1. **Title:** Burger King Restaurant Remodel
Address: 227 Mount Hermon Road
Applicant: Sunny Ghai / Ishar Investments
Property Owner: Scotts Valley Plaza, L.P.
Project Description: Consideration of a Design Review application DR20-002 and a Sign Design Review DR20-003 for an exterior remodel of an existing 2,340 square foot restaurant building (Burger King) including new parapet walls, new finishes and new signage.
Staff: Brenda Stevens, Associate Planner, bstevens@scottsvally.org

**City of Scotts Valley
PLANNING COMMISSION
STAFF REPORT**

Applications: Design Review #DR20-002, and Sign Design Review #DR20-003

Project Description: Consideration of a Design Review application to remodel an existing 2,340 square foot restaurant building (Burger King) and a Sign Design Review to replace the existing building signage.

A-3

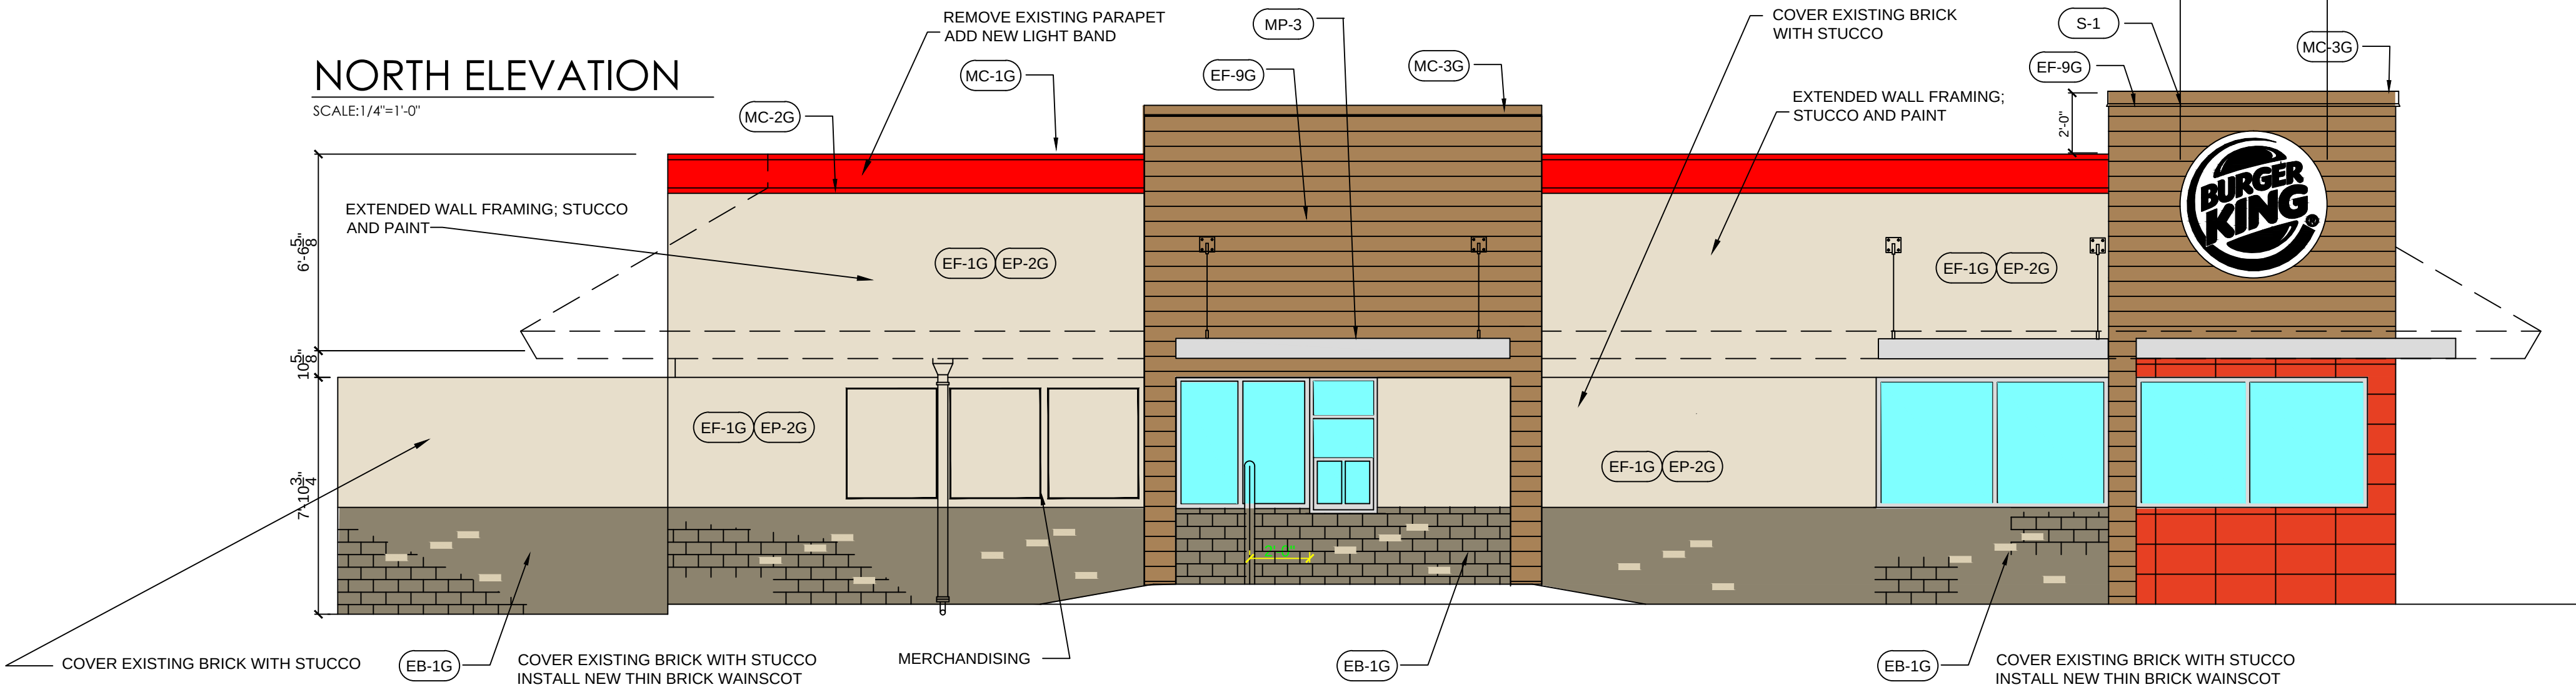
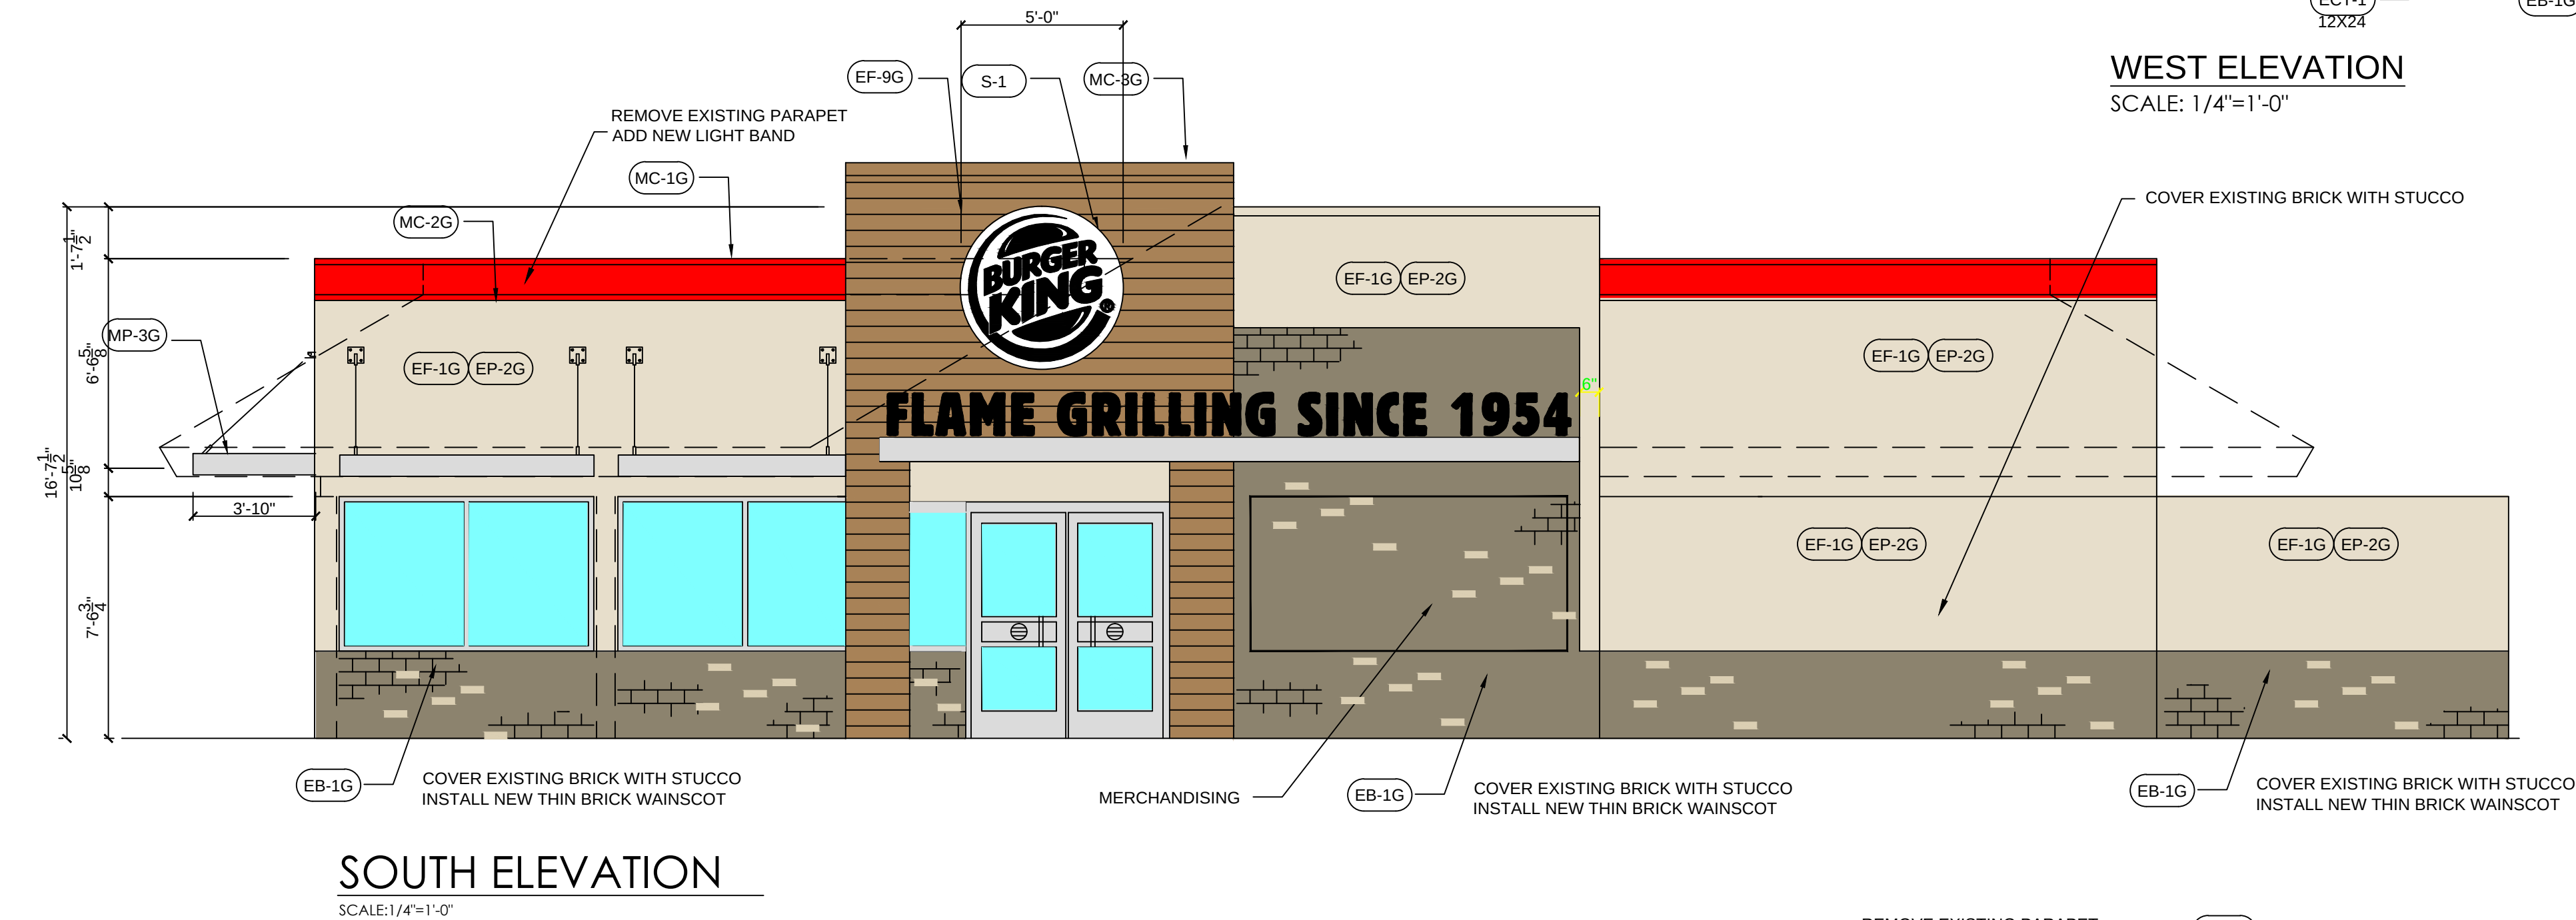
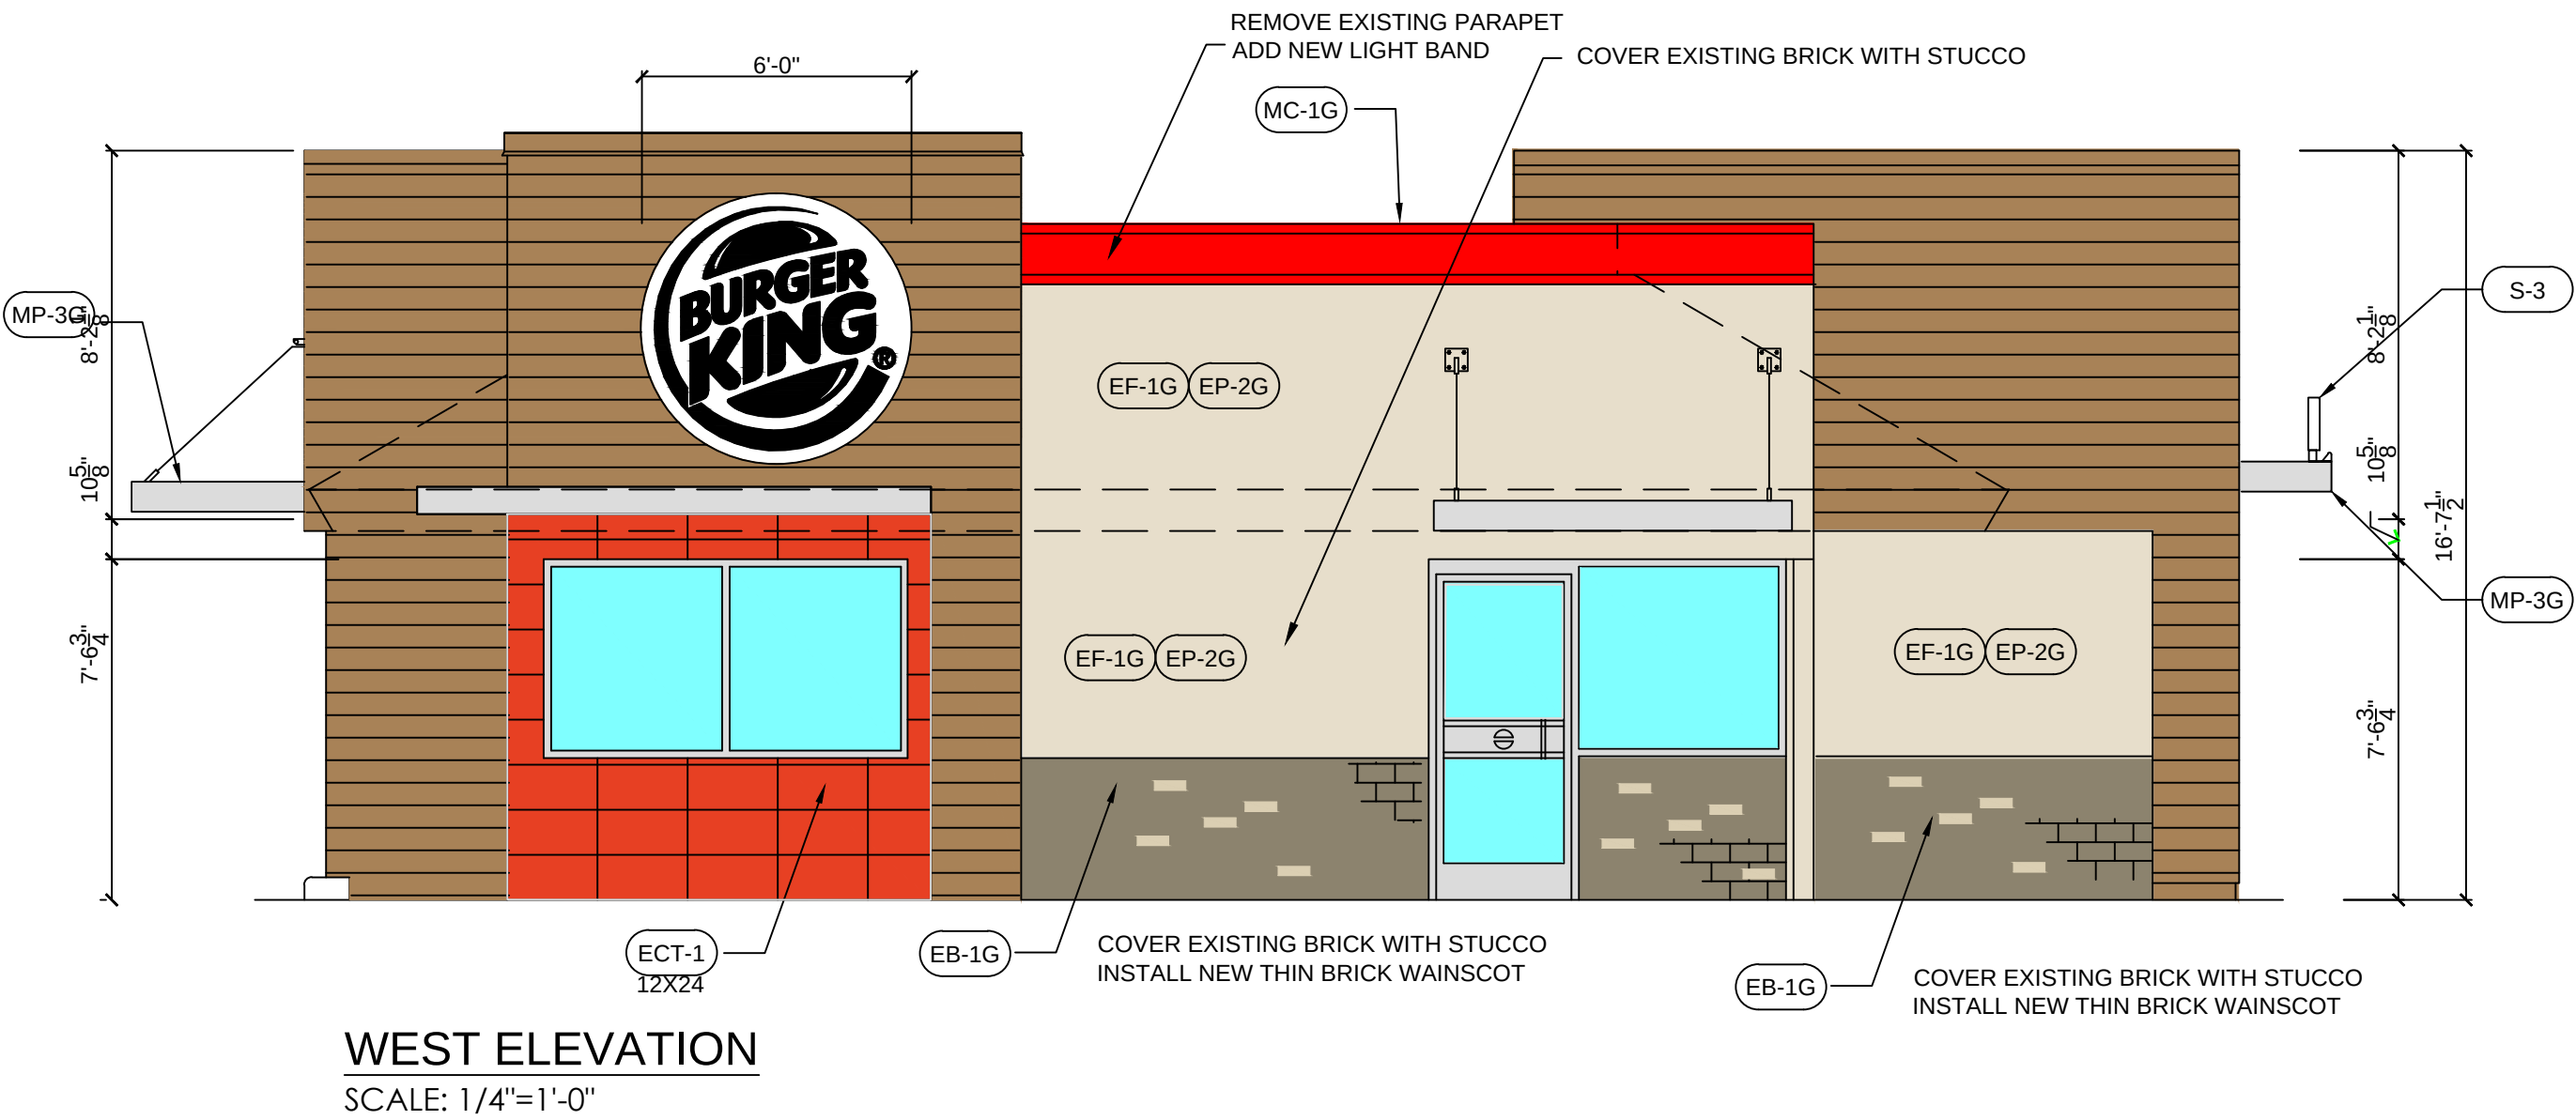
Staff believes two sections of the roof-top light band should be eliminated. The first section is (Sheet A-3 listed as North Elevation) along the drive-thru elevation to the left of the drive-thru window between the menu board and the pick-up window. The second section is (Sheet A-3 listed as East Elevation) the rear side of the building, from corner to corner. By eliminating these portions of the light band, staff believes it will lessen the visual light impact on the adjacent residence of the Spring Lakes Mobile Home Park and will not impact the building visibility or identification in any significant way.

- Number of pad signs will be subject to review and approval by the CDD:
Staff recommends reducing the quantity of logo signs from three to two and has stated this in the Conditions of Approval. By eliminating the logo sign on Sheet A-3 called out as the North Elevation near the building corner of the drive-thru exit, staff believes that this will reduce unnecessary light impact for residential neighbors of adjacent Spring Lakes Mobile Home Park. As this logo sign will be the least visible for business identification purposes for traffic along Mount Hermon Road staff believes the elimination of this sign will not significantly impact the business.

6. The applicant shall eliminate two sections of the roof-top light band on the drive-thru elevation located to the left of the drive-thru window (when facing the window) between the menu board and the pick-up window (Sheet A-3 listed as North Elevation). The second section is (Sheet A-3 listed as East Elevation) at the rear side of the building, from corner to corner.

7. The applicant shall eliminate one of the three logo signs for a total of two logo signs. The logo sign on Sheet A-3 listed on the plans as the North elevation on the drive-thru elevation shall be eliminated.
8. The two remaining logo signs (Sheet A-3 one listed on West and listed as South elevation) shall be reduced in size by one foot in diameter. The 6 foot in diameter logo sign shall be reduced to 5 feet and that the 5 foot diameter logo sign be reduced to 4 feet.
9. The applicant shall submit revised plans showing the light band and signage changes as conditioned.
